**RE: Sanderway
Carrboro, North Carolina
SPEC-18092**

McAdams was tasked with reviewing the stormwater design calculations and construction drawings provided to us by Jeff Kleaveland from the Town of Carrboro on August 30th, 2018. The purpose of this review was to determine how/if the Sanderway development meets the Town of Carrboro stormwater rules and to determine what analyses were performed to ensure the downstream neighbors will not be adversely impacted by the proposed Sanderway development. The following questions/comments were generated from the review and require additional information to ensure all applicable requirements are being met for the proposed development:

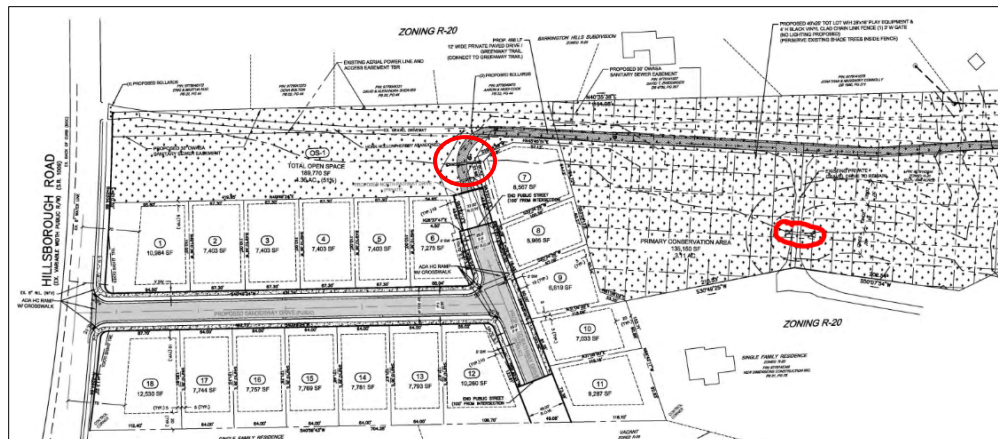
- o Is there a detention exemption for the site that gets the proposed development out of 1-, 2-, 5-, 10-, and 25-year storm peak flow detention? No hydrograph analysis has been presented for review to back up the detention requirements of the ordinance.
- o No information was provided to support a peak flow analysis was completed at the locations circled below and where runoff leaves the Sanderway property.

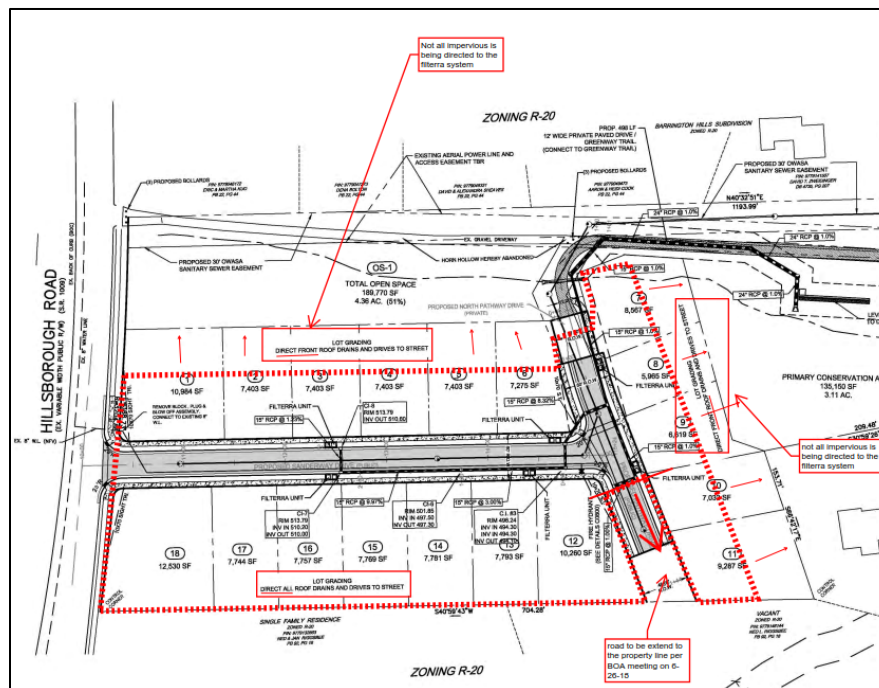
- o No calculations are provided to support 85% average annual removal rate for Total Suspended Solids (TSS)
- o No bypass impervious is shown in the SNAP tool, although the utility plan (sheet C0300) mentions that some areas will only take the front roof drains to the system (impervious areas on site are bypassed and do not enter the stormwater treatment system).

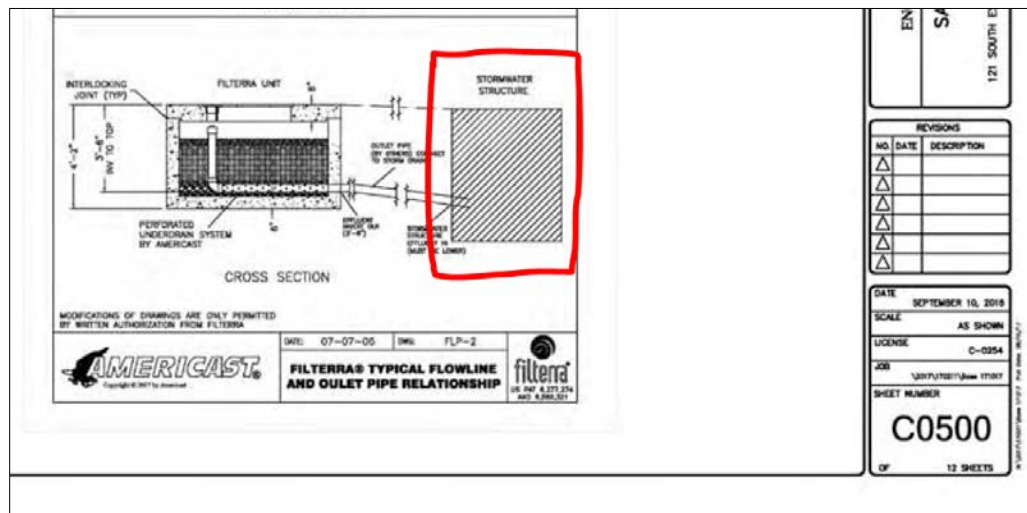
- o No calculations were provided to show how detention is being provided in the “Stormwater Structure” located on sheet C0500
- o What measures are taken to prevent backflow from the site drainage system to the stormwater Filterra system?

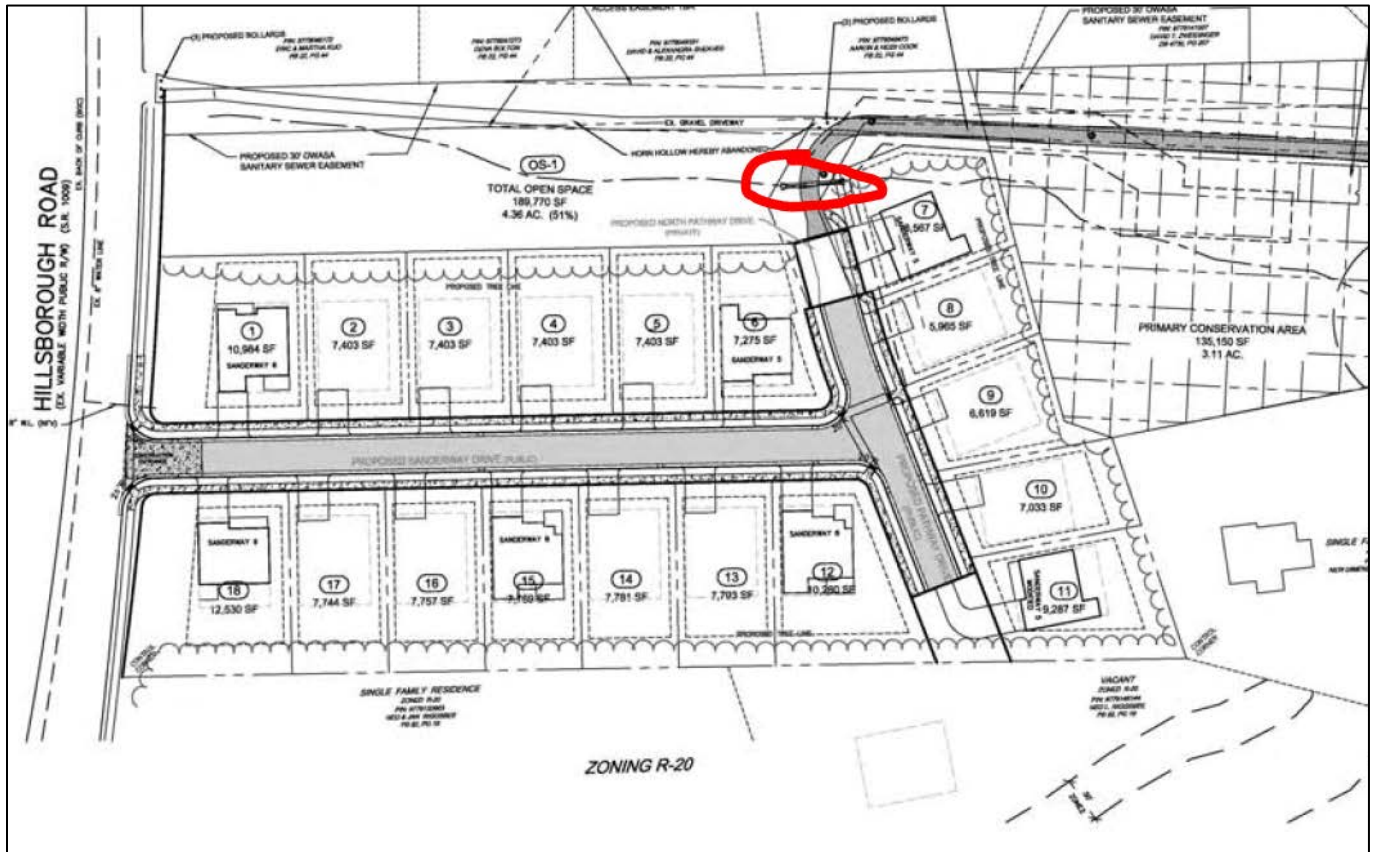
- o Is the existing 12" culvert where Sanderway connects to the greenway being replaced? Not labeled on plans
